Commission of Architectural Review
Certificate of Appropriateness Application
900 E. Broad Street, Room 510
Richmond, VA 23219
804-646-6569

Property Address: 2808 E Leigh St, Richmond, VA 23223

Historic District: Church Hill North

From: [Mandy Derby](#)
To: [Dandridge, Alex - PDR](#)
Cc: [Christopher Wingfield](#)
Subject: Re: 2808 E Leigh St -- seeking approval for alterations/repairs
Date: Friday, April 19, 2024 4:55:23 PM
Attachments: [image002.png](#)
[image005.png](#)
[image003.png](#)

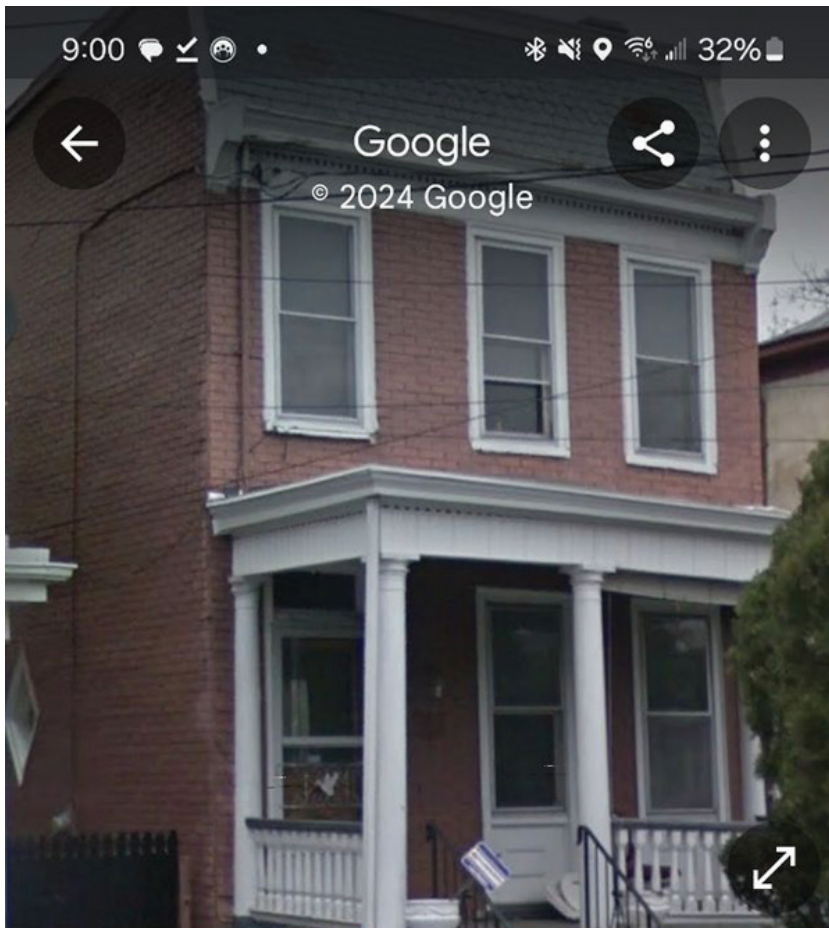
Just found this picture in our files from 2016 that shows the faux brick siding coming off, revealing the wood siding underneath. Looks like it was a faux brick!

IRON OR ALUMINUM WOOD-LIKE BALUSTRADE STYLE (1)

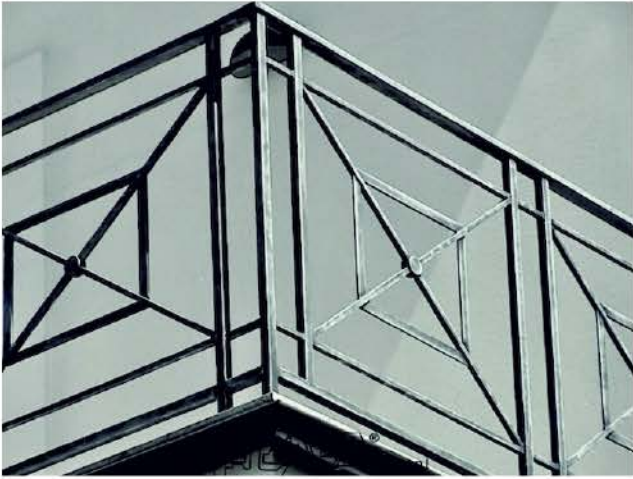
This is the style we're most interested in (minus the flourish ornamentation):

Do you need more information to approve this general concept direction on 5/28? I assume we'll need to get drawings approved down the road, once drafted, but I don't want to start that process if the overall direction isn't approved. Please let me know.

Because you are wanting to install a different siding type on the facade, as well as a new railing style, this application is lending itself more towards a full Commission Review. I can go ahead and schedule it for the May 28th, 2024 CAR meeting.

I will add that generally alterations that are made on historic building should be in-kind or based on physical or photographic documentation, which is also reflected in our guidelines. I can see if I have any older photos in our files if you wish to take inspiration from that.

All this being said, your present this to the commission, but there will be some discussion and push back on changing the siding on the front and adding a new railing.
